Site: 32 Market Place, Warminster, BA12 9AN
Prepared by: Chris Gray
Approved by: Neil Jaques
Date: 3 July 2026

- 1.1 This Technical Note (TN) has been prepared by Motion on behalf of Ellis and Partners in response to the Wiltshire Council (WC) holding objection on WC planning application number PL/2026/01683 in **Appendix A**.

WC holding objection on WC planning application number PL/2026/01683

Planning App Ref:	PL/2026/01683
Service Ref:	Drainage
Date:	14/05/2026

Figure 2.1 - Estimated extent of the 1% chance of surface water flooding each year including the 'upper end' allowance for the 2070s epoch for the 150-300mm depth scenario shown in the Government Flood Map for Planning Website built by the EA

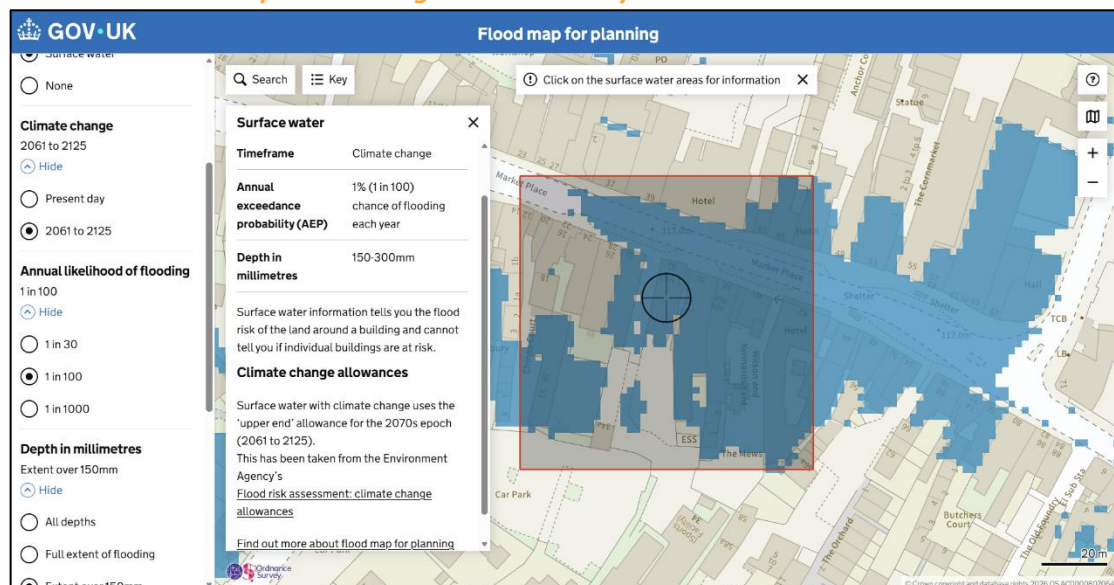
The applicant shall provide details of the proposed flood resilience measures, including confirmation of finished floor levels in relation to the predicted 1 in 100-year flood level (including appropriate freeboard) for both existing and proposed development. It shall clearly demonstrate the relationship between flood levels and internal floor levels.

- 2.1 Please see **Figure 4.1** below which shows the estimated extent of the 1% (1 in 100) chance of surface water flooding each year including the 'upper end' allowance for the 2070s epoch (2061 to 2125) for the 150-300mm depth scenario shown in the Government Flood Map for Planning Website built by the Environment Agency (EA).

- 2.4 Each depth band gives the modelled depth of water in a given scenario, not the probability of reaching a depth. On the basis it is almost entirely the estimated extent of the 1% chance of surface water flooding each year including the 'upper end' allowance for the 2070s epoch for the 150-300mm depth scenario that interacts

with the proposed development site, the hazard is assessed to be Low. However, it is still relevant to assess Building Thresholds, Finished Floor Levels (FFLs) and Access / Egress routes i.e. This surface water flood extent is shown to interact with the footprint of the proposed ground floor residential flat; the footprint of the retained ground floor commercial unit; and the red site boundary approximately 2m from the rear of the proposed single dwelling to rear of 32 Market Place. This surface water flood extent is also shown to interact with the access / egress to these proposed properties.
